NOTICE OF PROPOSED CHANGE IN PROPERTY

Petition: x151

PETITION NO. 151
 EASTSIDE COMMUNITY NETWORK
 4401 CONNER AVE.
 DETROIT, MICHIGAN 48215
 C/O LINDSEY NELSON
 PHONE NO. 734 995-4194

B						REQUEST ENCROACHMENT INTO NEWPORT 5503, 5511 AND 5517 NEWPORT AVE. (With Concrete Curb Inlet, Trench Drain Cobble Spillway, Concrete Curbs and Concrete Sidewalks)	CITY OF DETROIT CITY ENGINEERING DEPARTMENT SURVEY BUREAU	
A					JOB NO. 01-01			
DESCRIPTION REVISIONS		DWN WLW	CHD KSM	APPD KSM	DATE 04-18-18			DRWG. NO. X 151
		CHECKED KSM	APPROVED

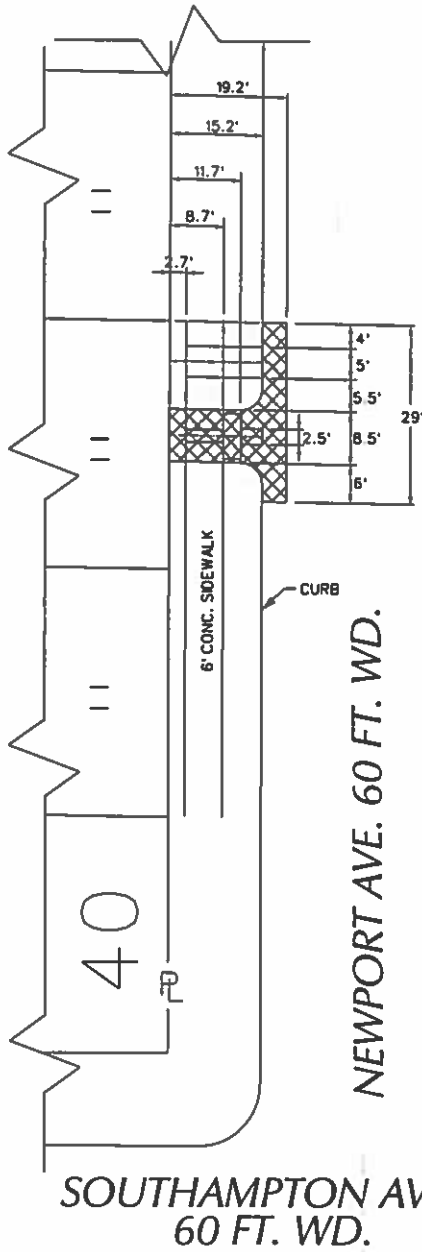
- Not Involved**
Encroachment requested for a concrete curb inlet and trench drain to collect storm water in the neighborhood. ECN will be responsible for maintenance and upkeep. P&DD supports working with DWSD to ensure that the pitch of the inlet is such that there is no ponding on the sidewalk, suggests that the rocks be removed for safety, allowing the curb to continue all the way to the sidewalk and that all ADA accessibility requirements are met.
